ACCESSION NBR:9711190115 DOC.DATE: 97/11/11 NOTARIZED: YES DOCKET #
FACIL:50-244 Robert Emmet Ginna Nuclear Plant, Unit 1, Rochester G 05000244
AUTH.NAME AUTHOR AFFILIATION
MECREDY,R.C. Rochester Gas & Electric Corp.
RECIP.NAME RECIPIENT AFFILIATION
VISSING,G.S.

SUBJECT: Forwards responses to 970331 RAI re proposed mod of Ginna spent fuel storage pool.

Subject: Response to Request for Additional Information - Spent Fuel Pool (SFP) Modifications - SFP Cooling Concerns (TAC No. M95759)
R.E. Ginna Nuclear Power Plant
Docket No. 50-244

FIGURE 2-1 SFP HEAT LOAD - FULL CORE DISCHARGE
40°F LAKE WATER TEMPERATURE

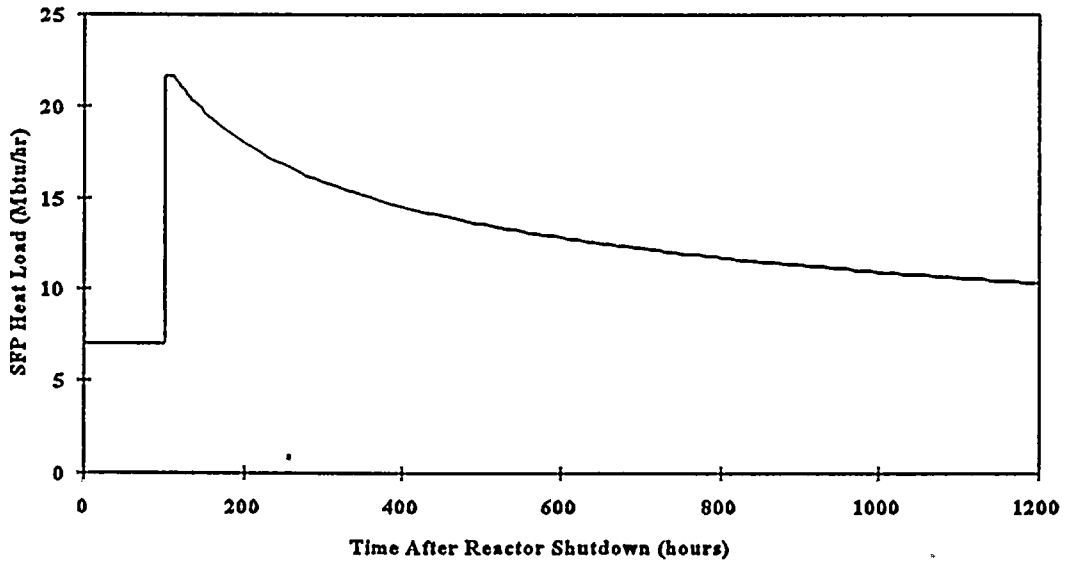
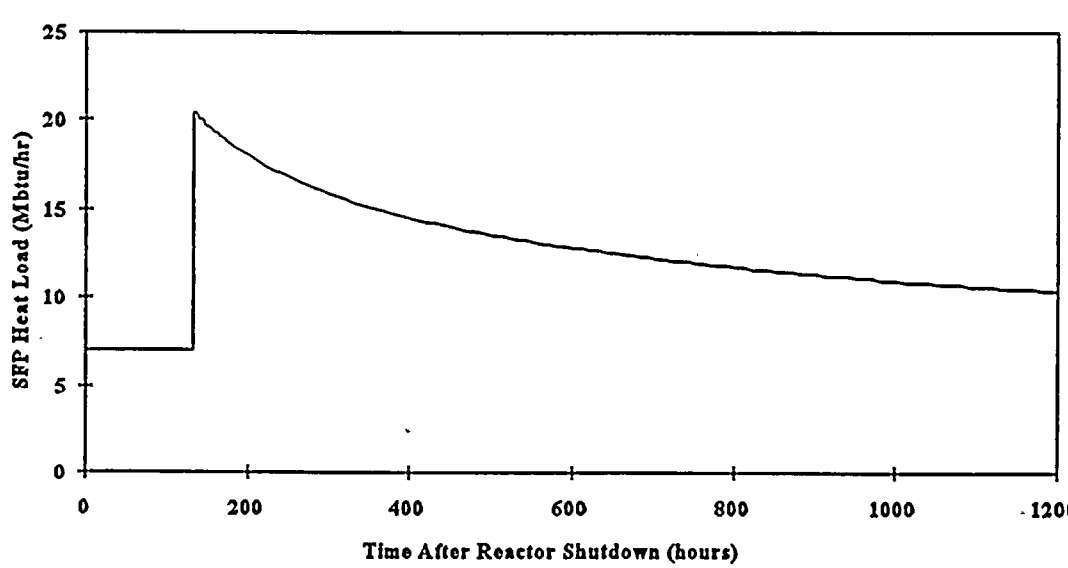
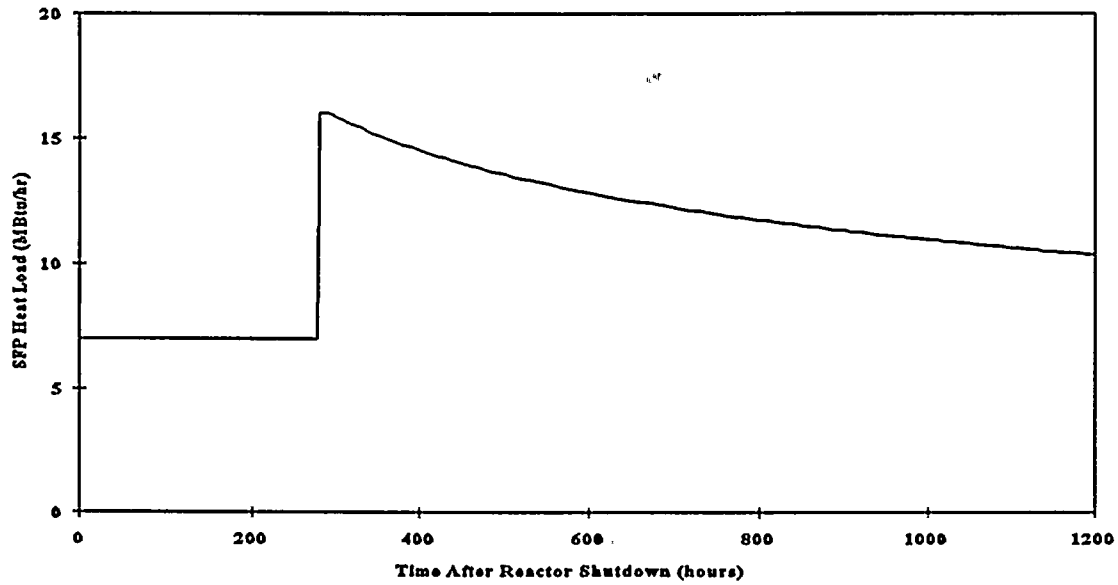
In Section 5.7 of the SFP Re-racking Licensing Report, Ginna states that the technical specification (TS) limit for the SFP water is 150°F which is achieved with the present SFP cooling system. The heat removal capability of the SFP cooling system heat exchangers varies as the temperature of Lake Ontario water varies. Therefore, the duration of reactor shutdown required prior to any SFAs discharged to ensure that the SFP water temperature does not exceed its 150°F limit is a function of Lake Ontario water temperature. For a full core off-load scenario, the following summarizes the reactor shutdown times required prior to the discharge of any SFA for three lake temperatures (40°F, 60°F, and 80°F) to prevent the SFP water from exceeding the 150°F limit:

Have these restrictions required for SFAs to decay in the reactor prior to the discharge of any SFA been incorporated in the Ginna TS? If not, provide detailed justifications for not having these restrictions imposed in the TS.

Also, provide the decay heat loads in the SFP and the corresponding calculated SFP water temperatures as a function of reactor shutdown time for each of the above cases.

The decay heat load vs. time used for the full core off-load for each of the Lake Ontario water temperatures is shown in Figures 2-1, 2-2, and 2-3. The increase in SFP heat load above the background value in the figures corresponds to the placement of the full core off-load in the SFP after the required in-reactor decay time.

**FIGURE 3-1 SPF HEAT LOAD -
NORMAL BATCH OFFLOAD
(40°F, 60°F & 80°F LAKE WATER TEMPERATURES)**

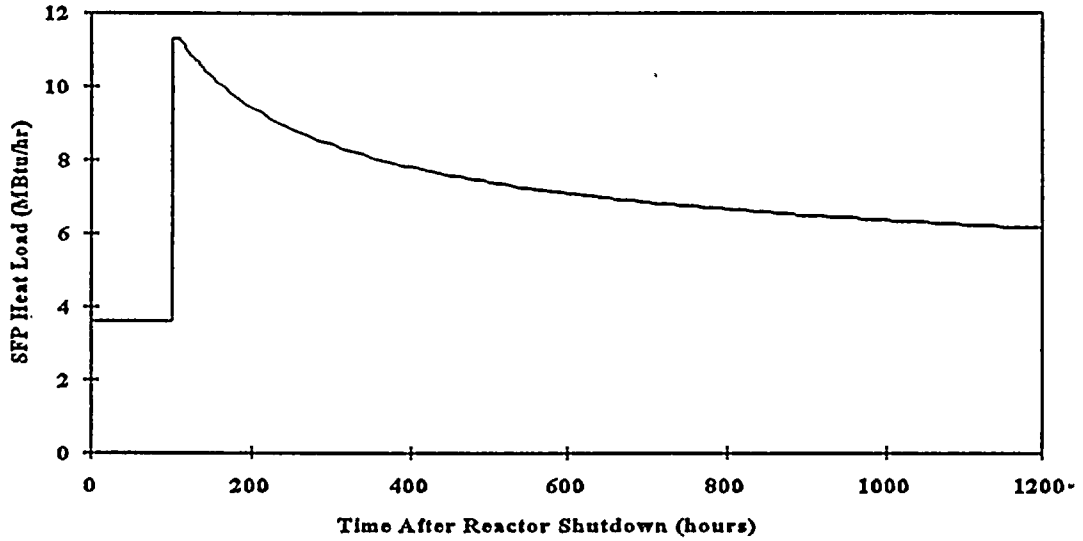
For the normal (routine refueling with 1/3 core discharged) discharge scenario as discussed in Section 5.5.2.1 of the SFP Re-racking Licensing Report, provide the decay heat loads in the SFP and the corresponding calculated SFP water temperatures as a function of reactor shutdown time. Also, indicate the lake water temperature which was used in the analysis.

This limiting design decay heat load vs. time used for a 1/3 core off-load is shown in Figure 3-1. The increase in SFP heat load above the background value 100 hours after reactor shutdown in the figure corresponds to the placement of the 1/3 core off-load into the spent fuel pool.
